CONSTRUCTION PLANS
FOR
SKYLINE AT LORSON RANCH FILING NO. 1
STORM SEWER
CONSTRUCTION PLANS
including STREETS (FOR INFORMATION ONLY)

SKYLINE AT LORSON RANCH FIL. NO. 1
STORM SEWER
CONSTRUCTION PLANS

DATE: NOV 30, 2020
PROJECT NO. 100.063
SHEET NUMBER C0.1
TOTAL SHEETS: 18

**TYPICAL SECTION 50' R.O.W.
RESIDENTIAL URBAN LOCAL**
NOT TO SCALE

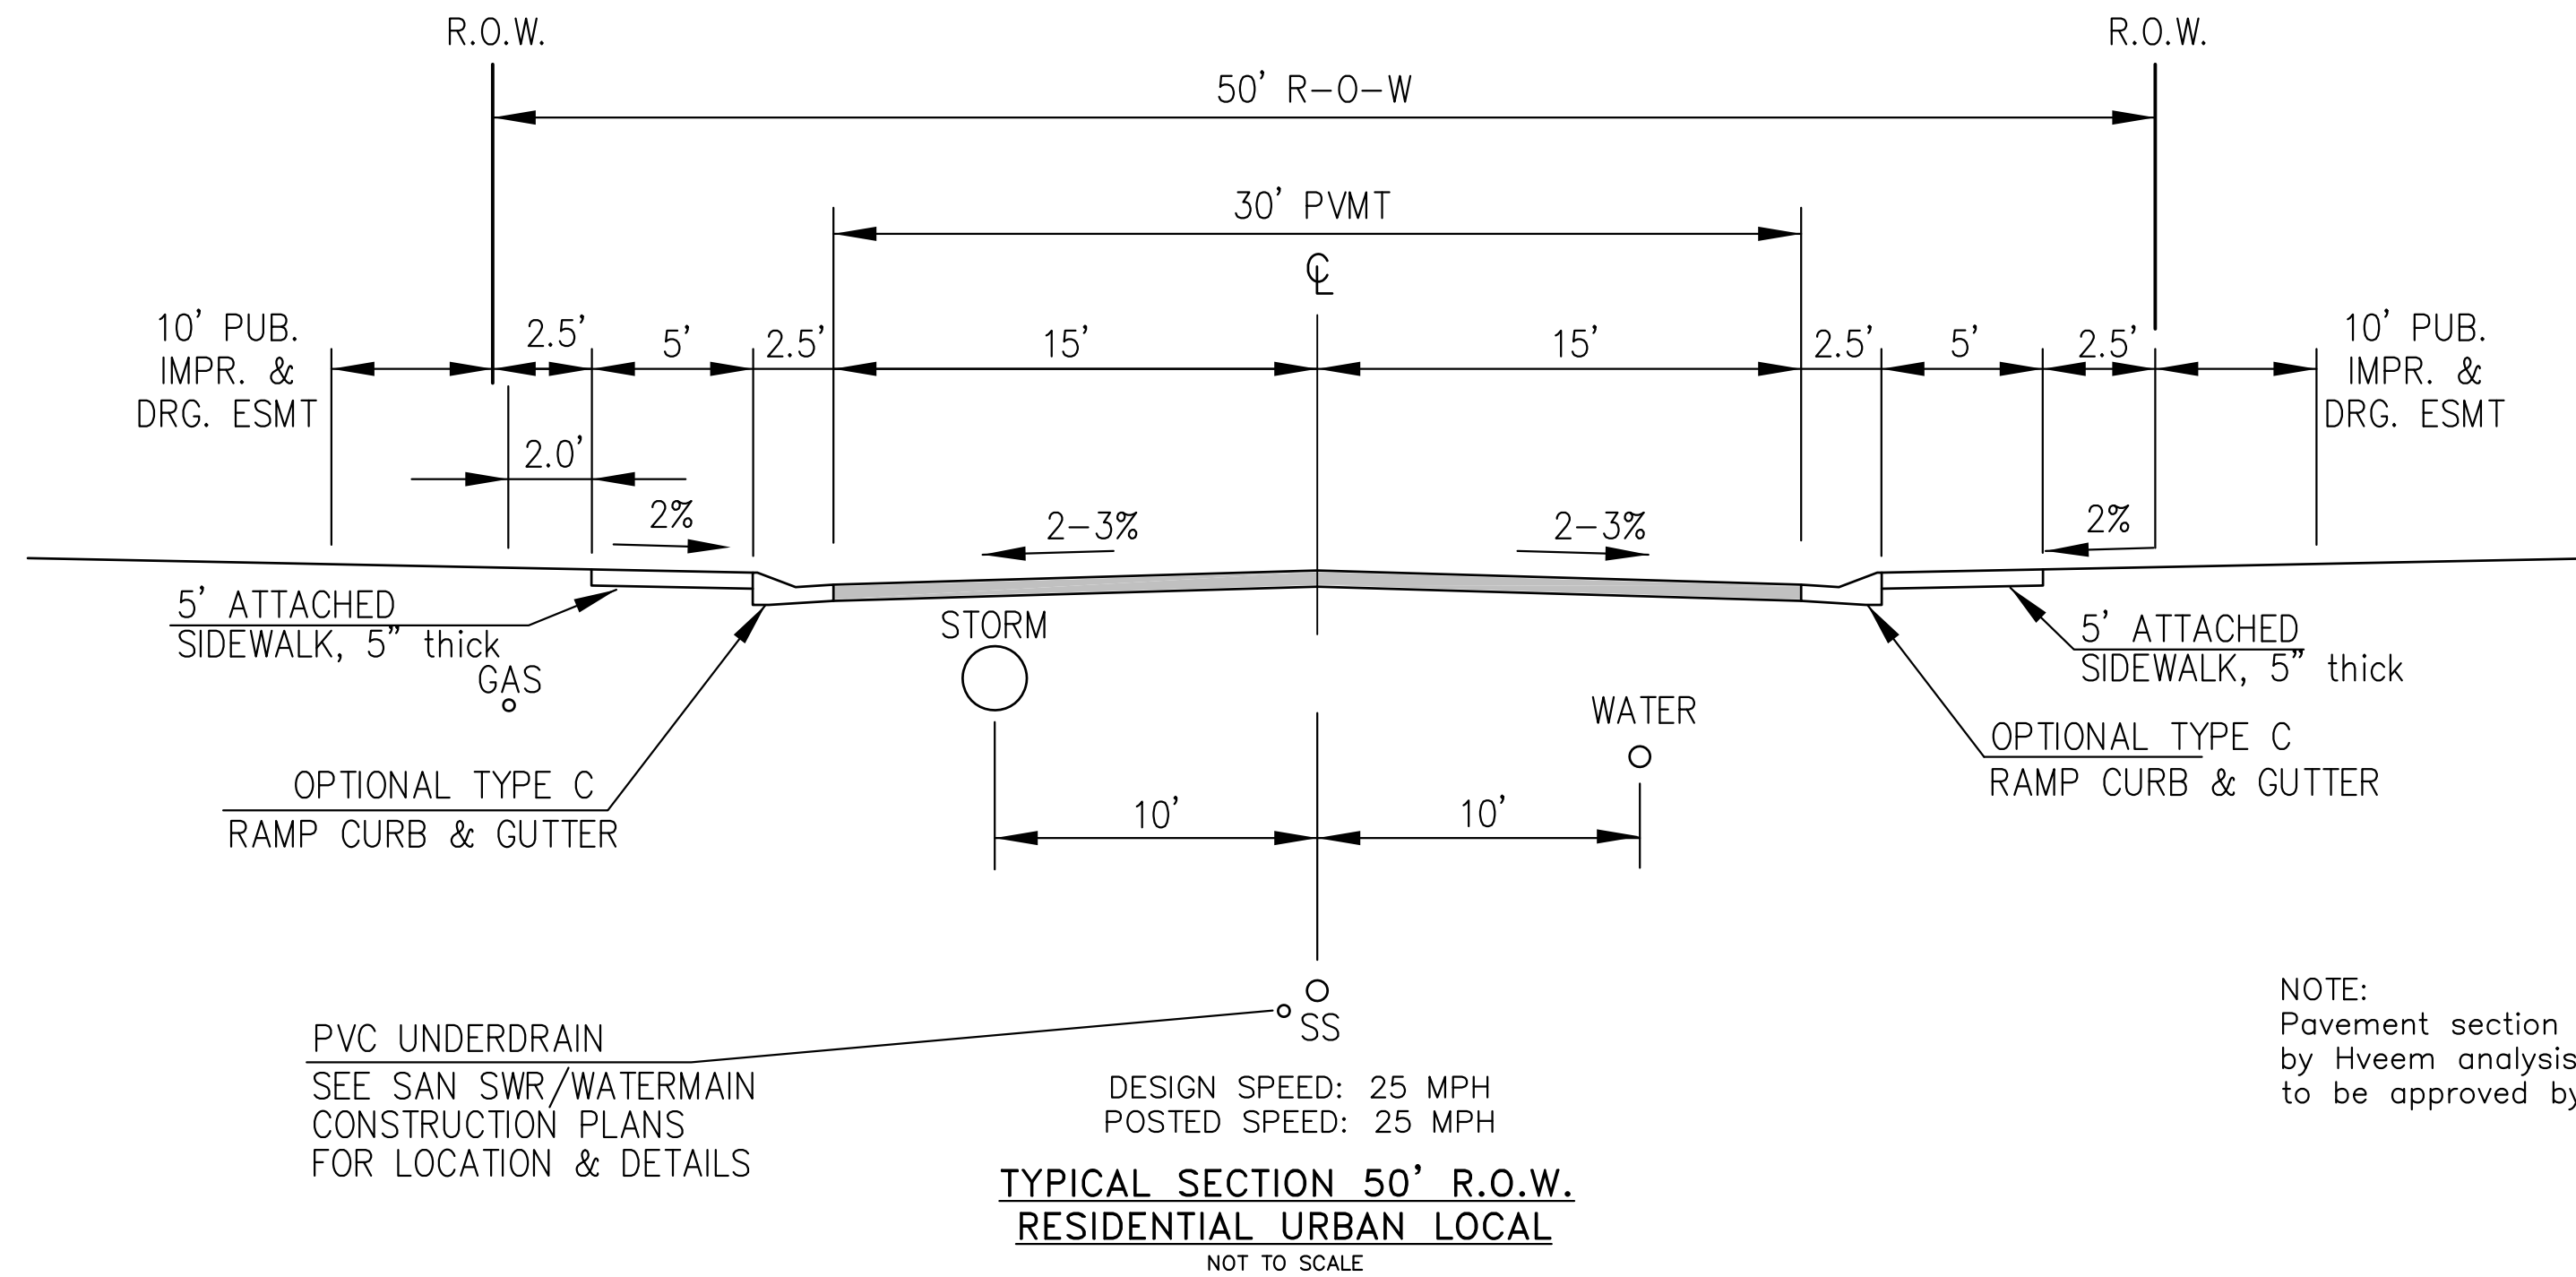
verify if this is renamed

SIGNING AND STRIPING PLAN
SKYLINE AT
LORSON RANCH FIL NO. 1

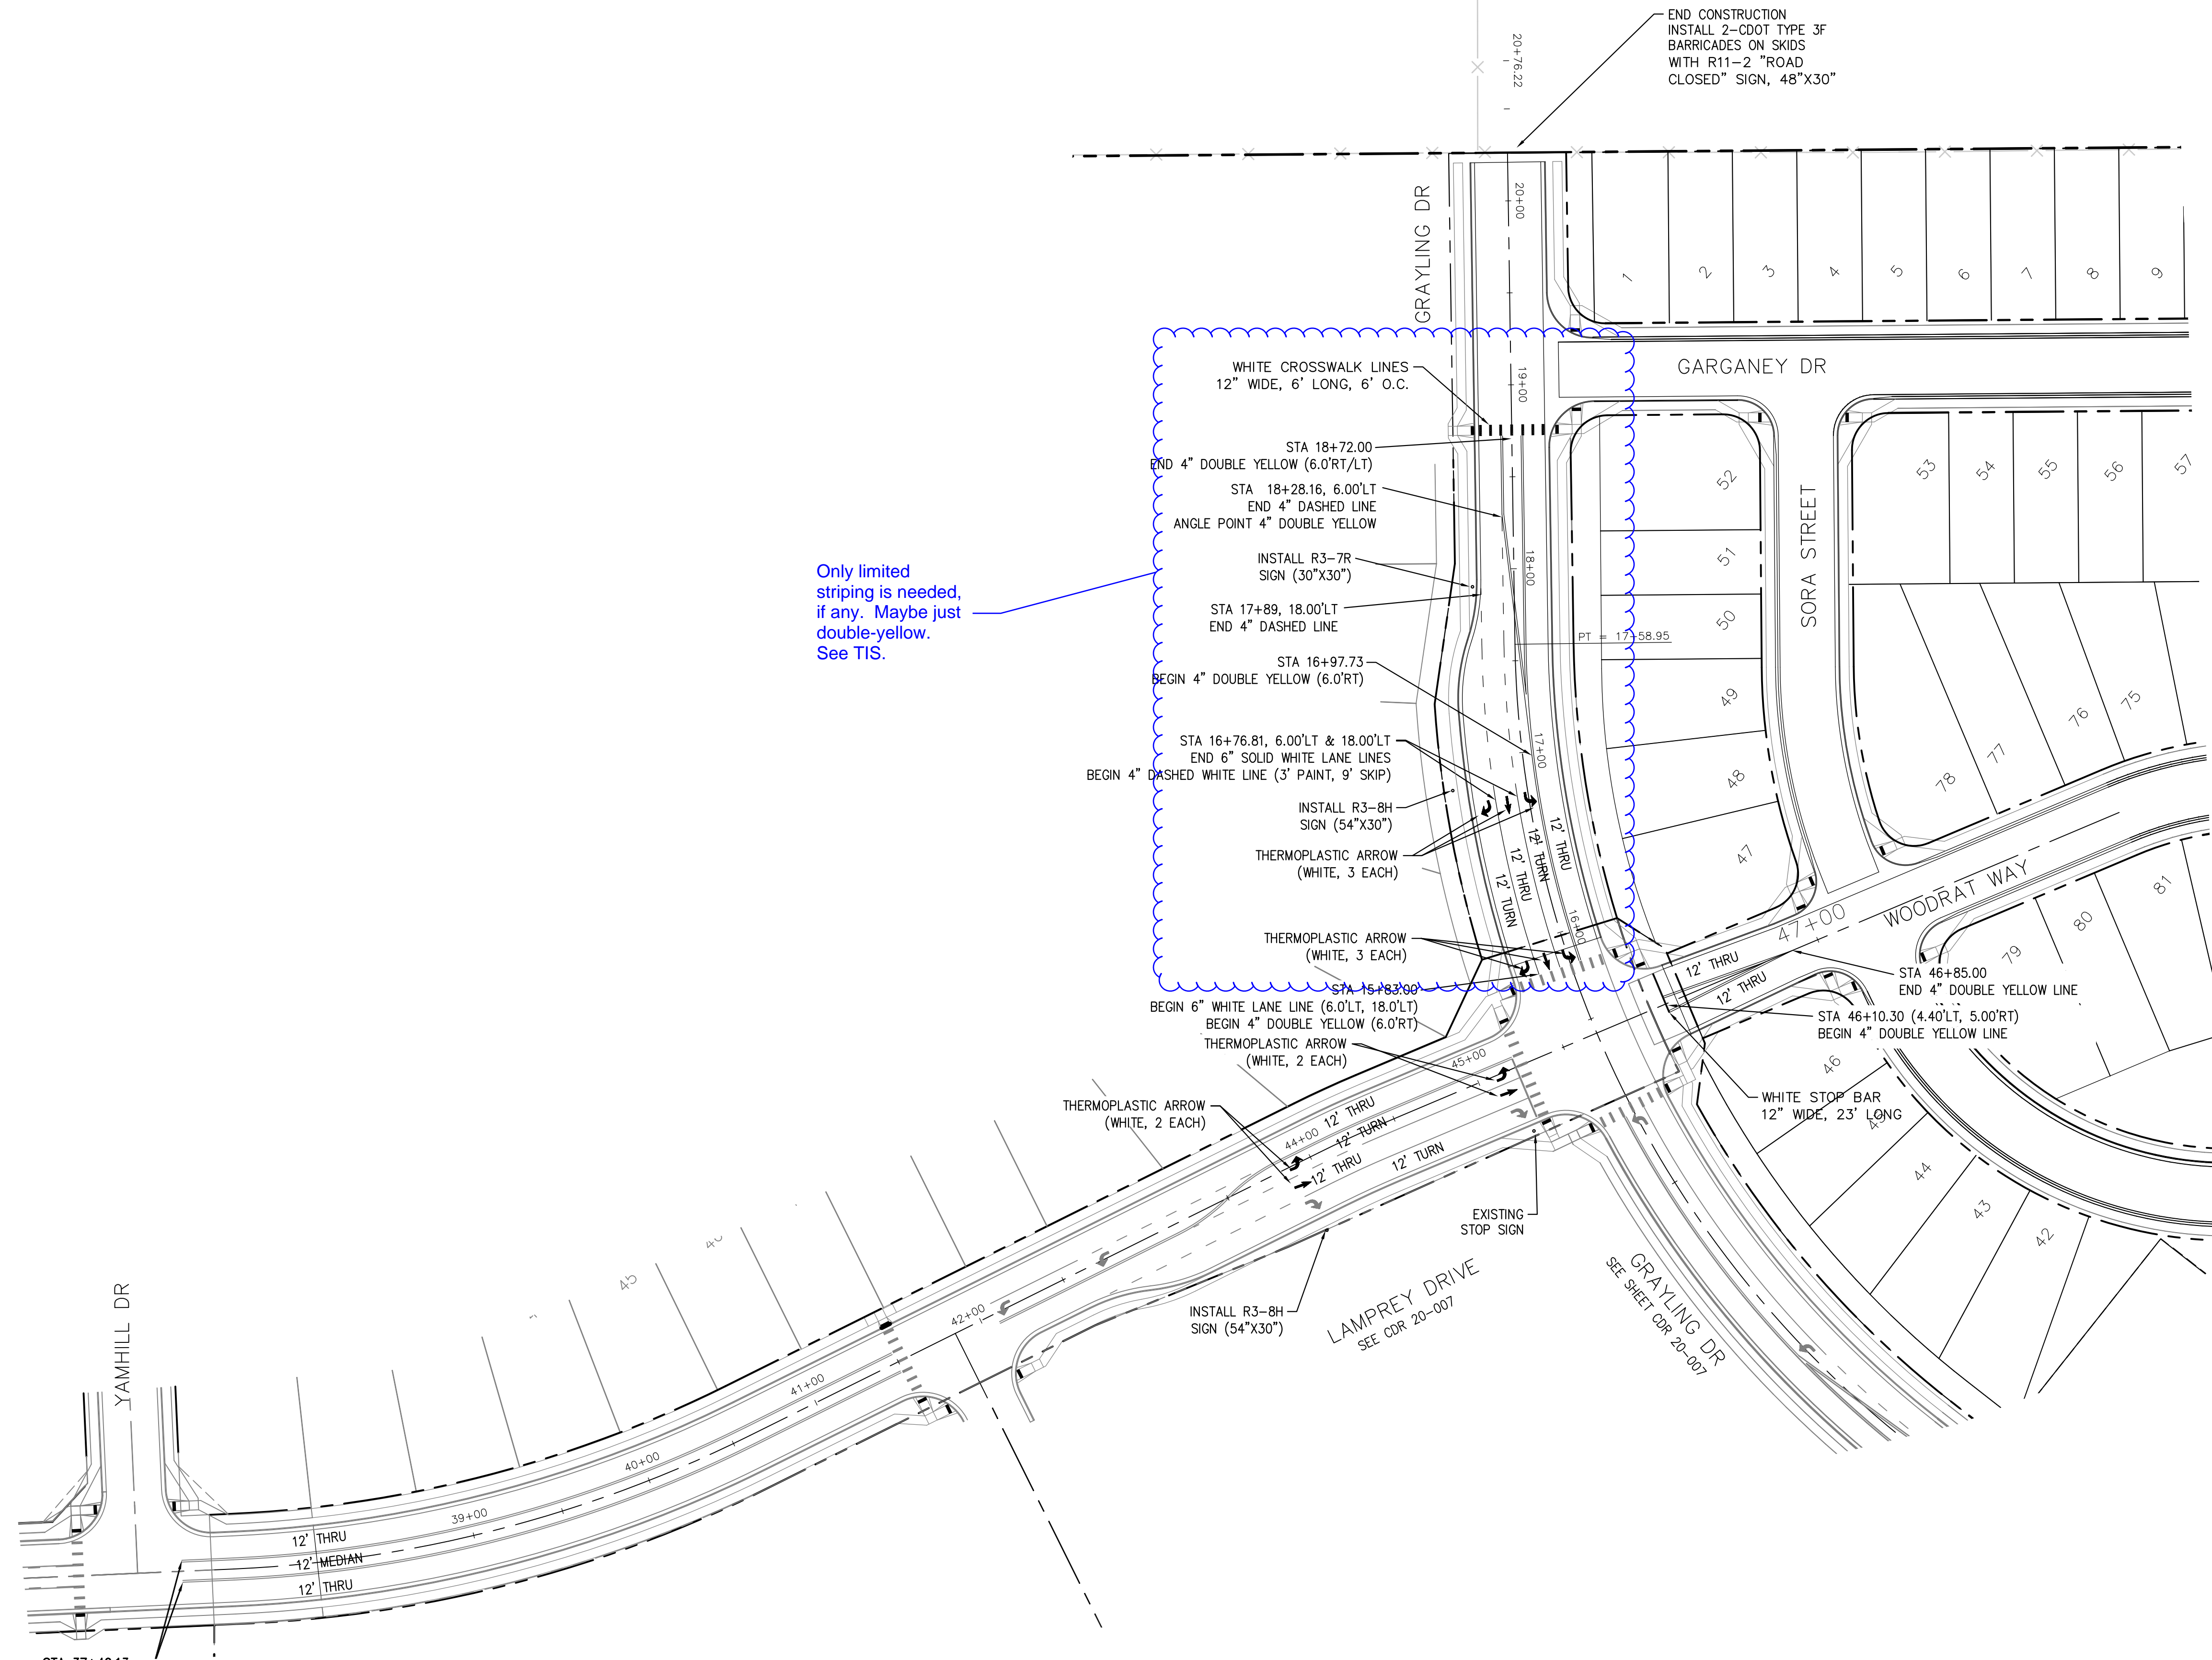
Only limited striping is needed, if any. Maybe just double-yellow. See TIS.

**STORM SEWER LATERAL 'A'
STORM LATERAL 'A'
AND POND C4 IMPROVEMENTS**

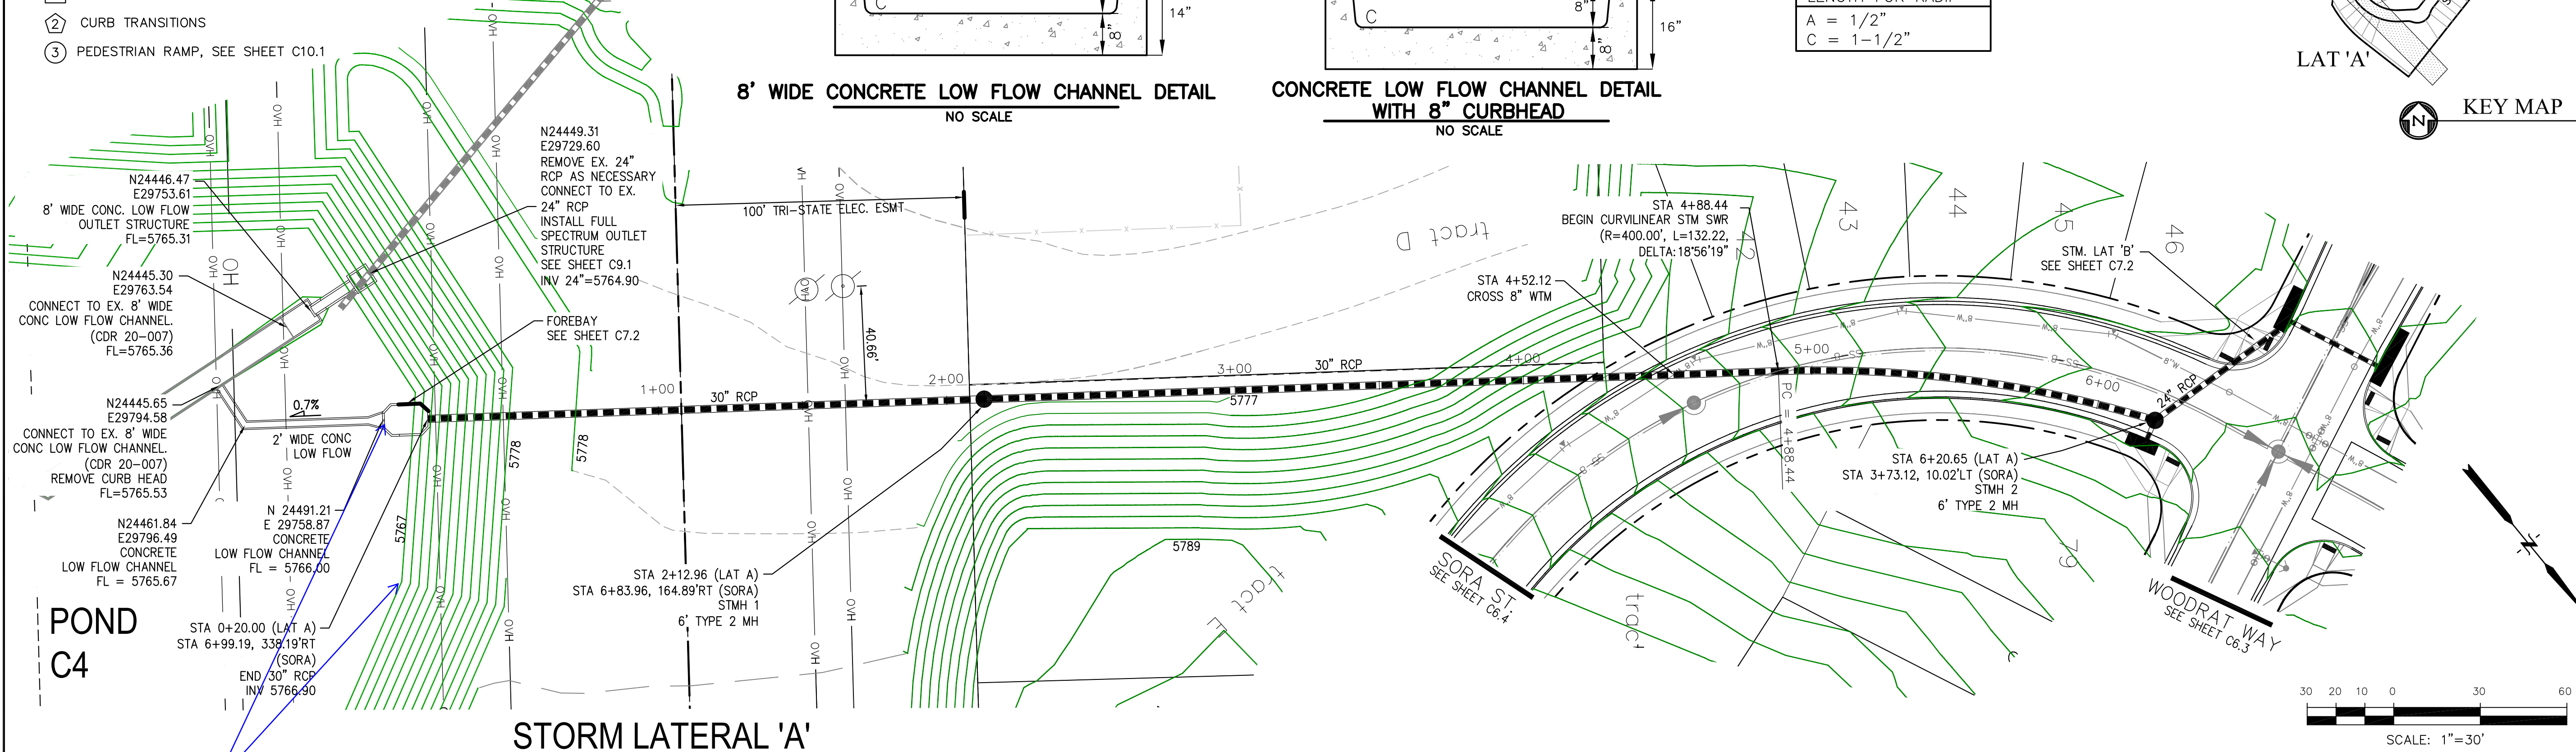
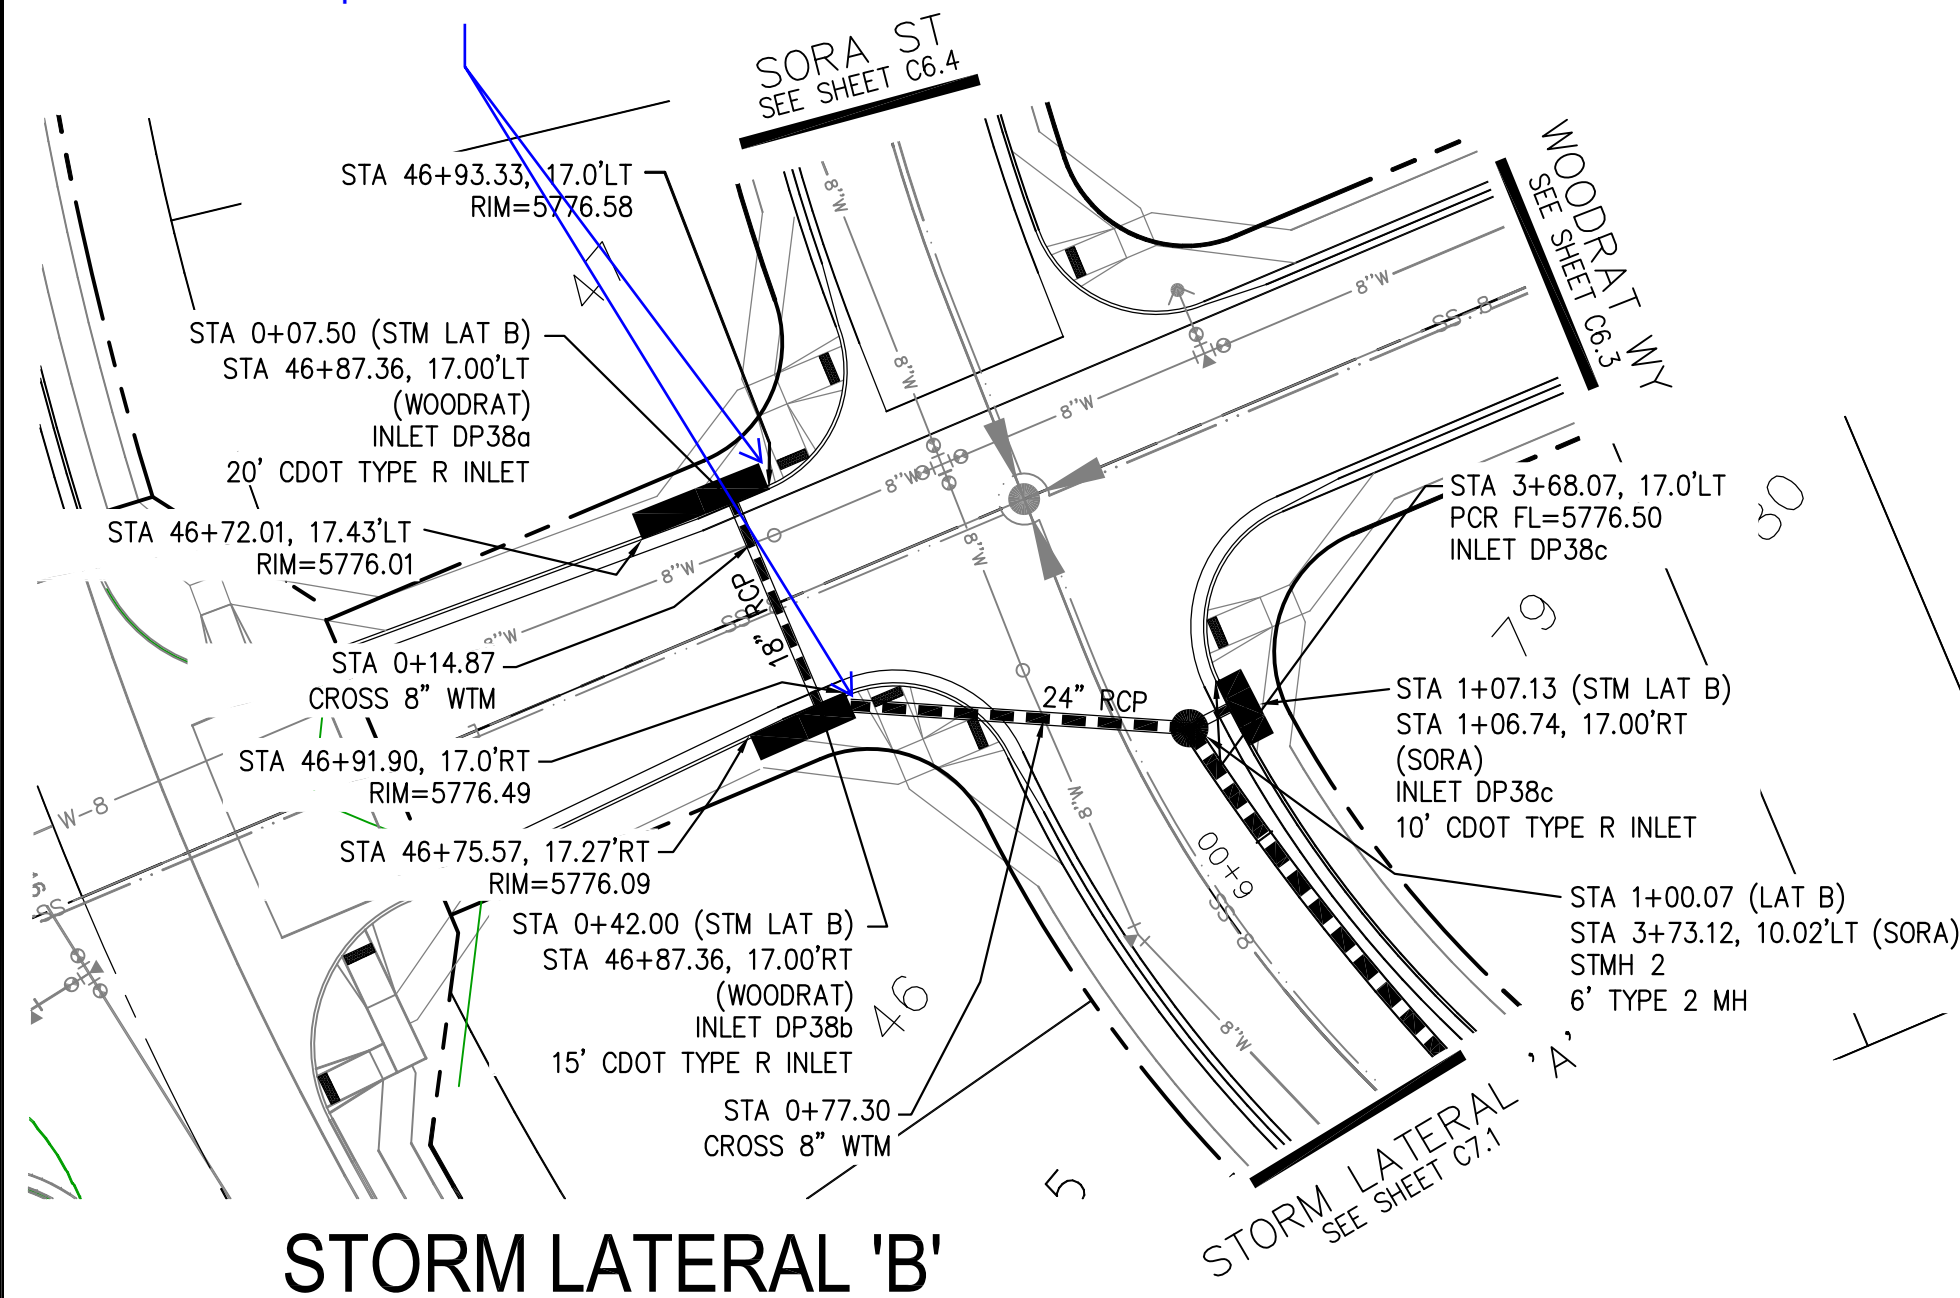
Move the forebay as far from the pond outlet as possible
